TECHNICAL MEMO

Geotronics AB, Technical Support Dept., Danderyd, SWEDEN, September 1997

TI/9702A

- Level:** 3.
- Instrument type:** Geodimeter system 600.
- Subject:** Vertical servo not working.
- Description:** The vertical servo function on the SRV and SRV2 boards can break due to ESD through the vertical servo knob. Replace IC46 and IC49 on the SRV/SRV2 boards to LM6482 RAIL-RAIL OP X2.
- IC46, IC49 LM6482 RAIL-RAIL OP X2 Part no: 571 804 246
- Mark the SRV board with rev. D02/08 and SRV2 board with rev. D00/04.
- Perform this modification if the vertical servo is not working.

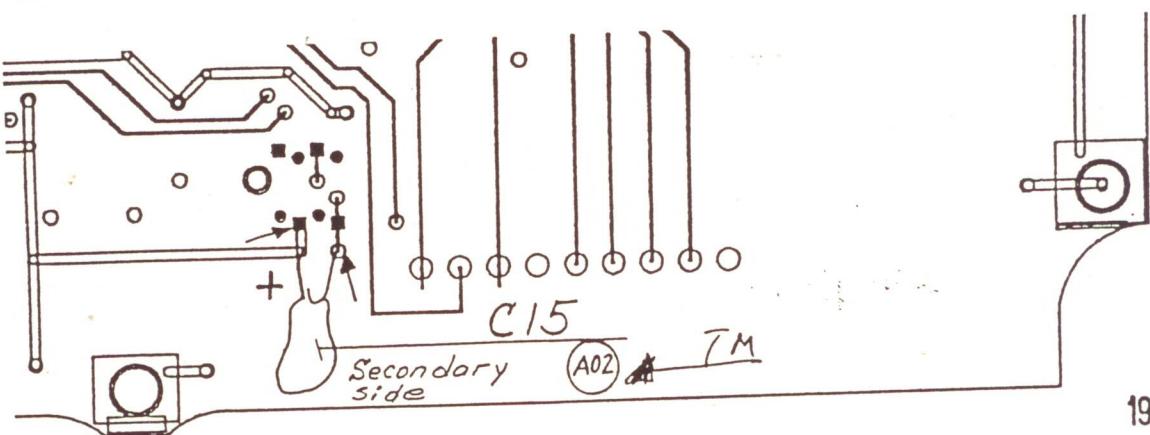
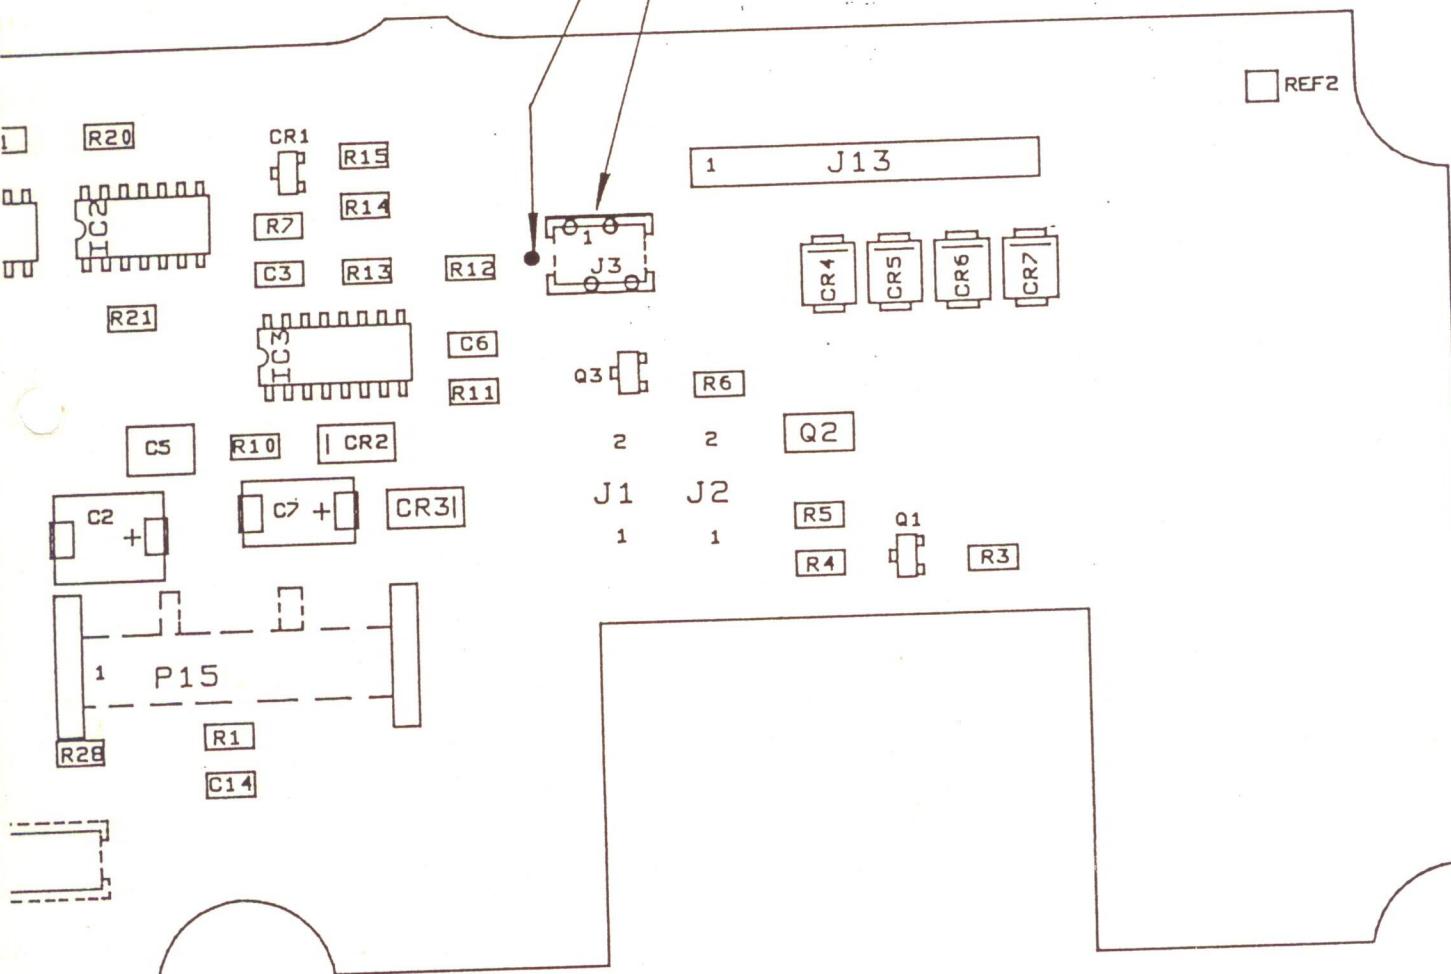
"Large" spreads at certain distances, caused  
by disturbance generated in the display-  
illuminationcircuitry

1. Change R6 6,8kohm to 2,2kohm
2. Fit C15 to J3-1 (+5V) and J3-2

Rev A01 -> A02 See Fig.  
Rev B01 -> B02 See Fig.  
Rev C00 -> C01 See Fig.

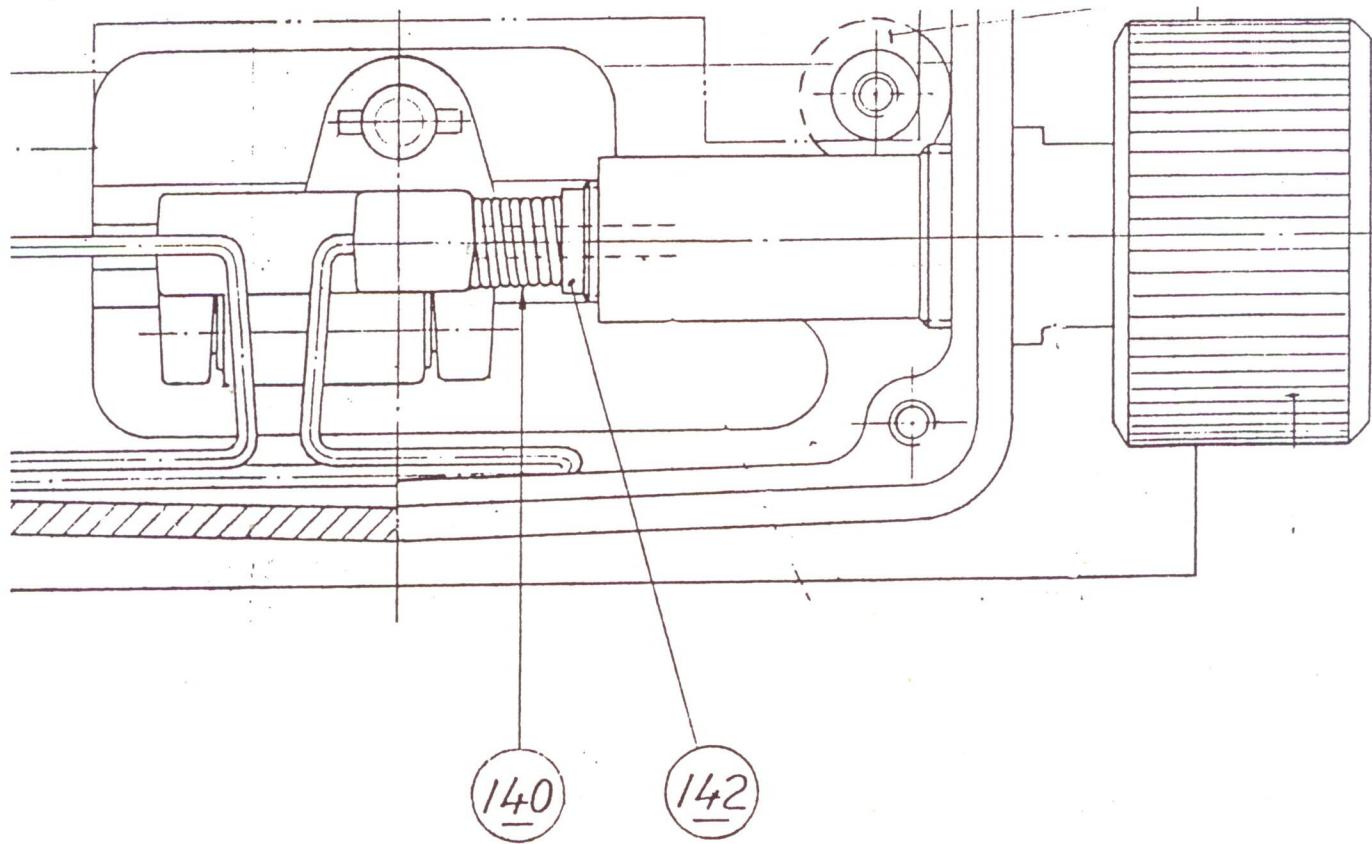
Symptom: Erratic movement of instrument unit when motionadjustments completed, haircross not fixed to measuringpoint.

Description: Take out the motionadjustment screw and remove the spring (140) and teflon insert (142). Remount and check function.

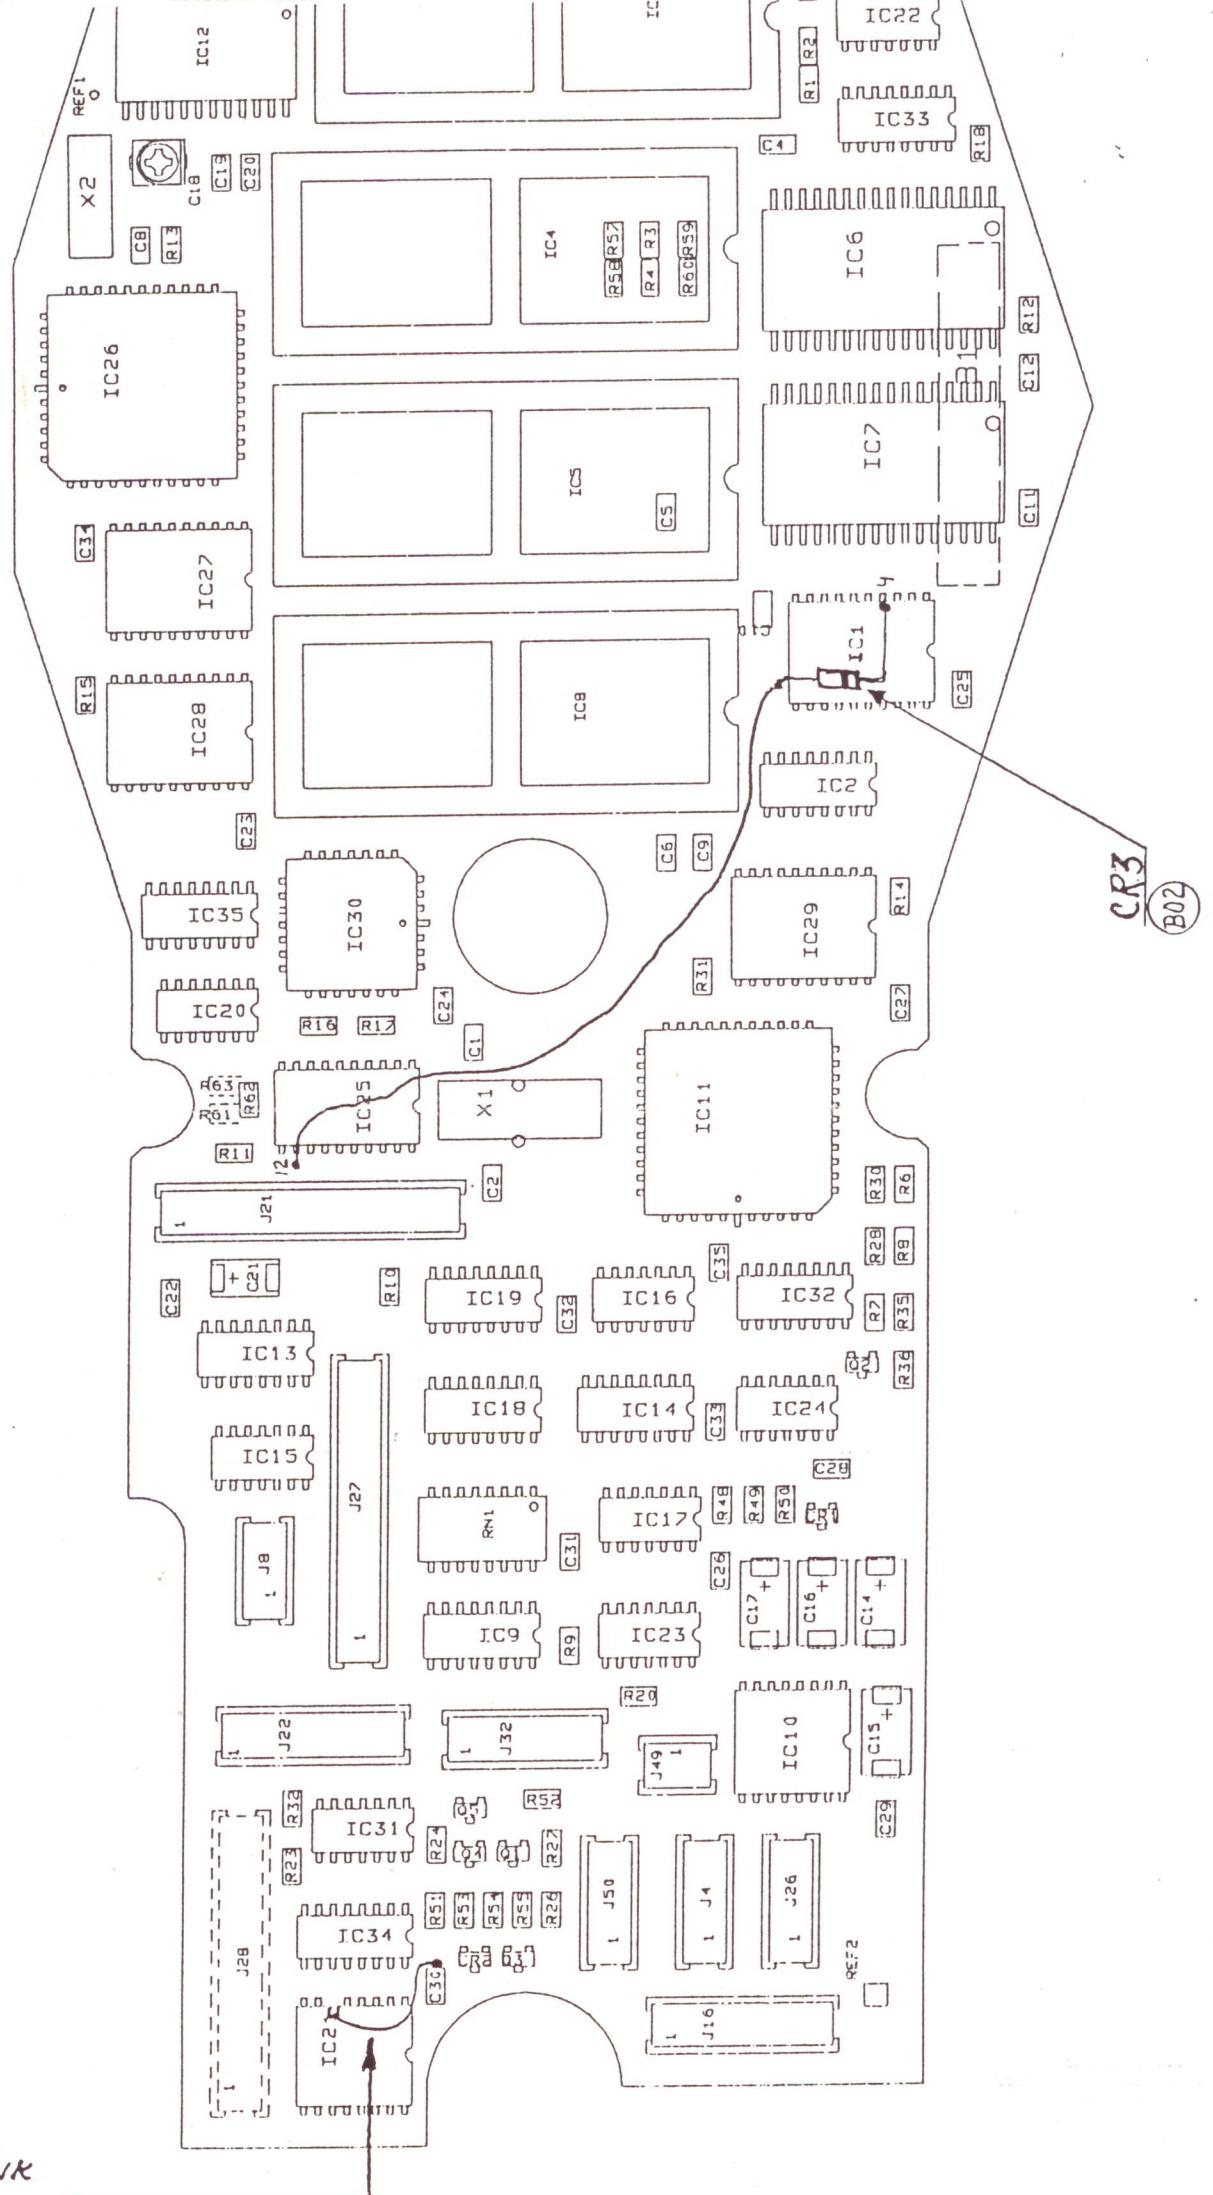
DESCRIPTION: Increased risk for memory loss due to  $V_{cc}$  loading.

REMEDY: Connect the diode CR 3 between IC 1 pin 4 and IC 25 pin 12 with the cathode on IC 1.

Disconnect IC 21 pin 6 from the PCB and connect it to  $V_{cc}$  (C 30).
